EPA Evaluation of the P.A.S.S. KIT Device Under  
Section 511 of the Motor Vehicle Information and Cost Savings Act

Test and Evaluation Branch  
Emission Control Technology Division  
Office of Mobile Sources  
U.S. Environmental Protection Agency

EPA Evaluation of the P.A.S.S. KIT Device Under Section 511 of the Motor Vehicle Information and Cost Savings Act

ATTACHMENT A

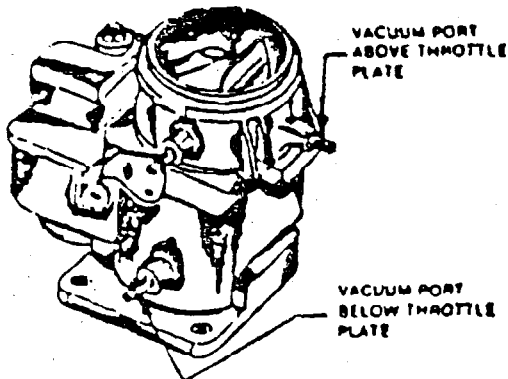
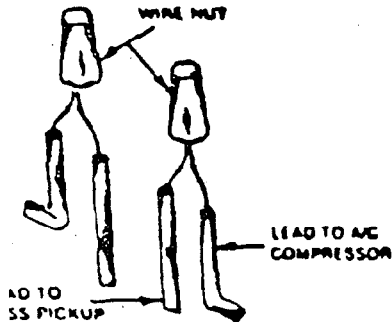
The installation instructions (Attachment A) that were provided with the application did not adequately describe how the user should make the optional adjustments to the device. As a result of several discussions and letters (Attachments D, E, F, G, and H), the applicant revised the installation instructions to include the changes given in Attachment G.

\* EPA NOTE: The installer may encounter moderate difficulty in locating the proper vacuum line. Vacuum port elevation/location is not always indicative of the type of vacuum signal. Also, some Fords have dual advance (two vacuum lines).

## New Instruction #2:

Set red dot on adjusting screw (found under removable rubber cover) to line up with the 4,6, or 8 cylinder setting position shown on the body of the switch. Locate a suitable existing mounting bolt, or drill a 1/8" hole and mount the unit with the sheet metal screw provided. Mount switch to allow screwdriver access to adjustment screw.

## New Instruction #6:

You have now completed the installation of your P.A.S.S. KIT. However, if you wish, additional "fine tuning" can be accomplished as follows:

1. Remove black protective cap.
2. To have compressor clutch cut out earlier, turn screw clockwise one/tenth turn at a time.
3. To have compressor clutch cut out later, turn screw counter clockwise one/tenth turn at a time.
4. Replace black protective cap. (The black protective cap must be replaced.)

The above described fine adjustment is easily accomplished if you can hear or "feel" your A/C disengage. If not - we suggest that you temporarily run a wire from the P.A.S.S. KIT switch into the passenger compartment. Connect to a 12 volt bulb or circuit tester and run wire back to the A/C clutch lead. When bulb is lit, A/C clutch is engaged. When bulb is off, A/C clutch is disengaged.
